Re: 2329 SW Old Port Rd., Lee's Summit, MO (The Oakmont)

Vista Structural Engineering, LLC was asked to address the following inspection item for the project located at above referenced address. Please see the following attached partial plans and Vista Structural's response:

Covered Deck Partial Plan

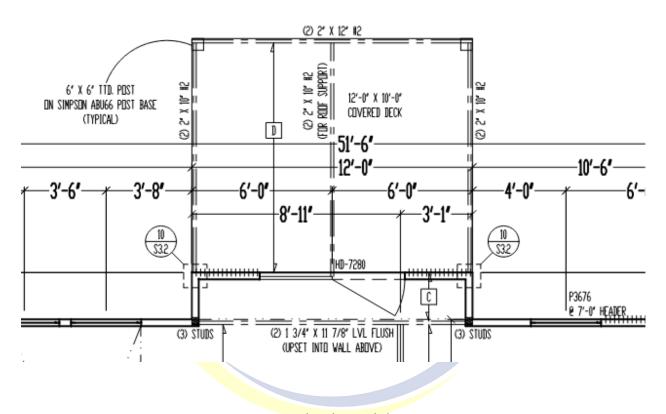
Inspection comment: "(2) foundation piers were constructed at the back covered patio of the residence instead of (3) indicated on current plan set"

Vista Structural's response: Please see attached covered deck & foundation partial plans. (2) Type K, 24" dia x 36" deep piers are acceptable.
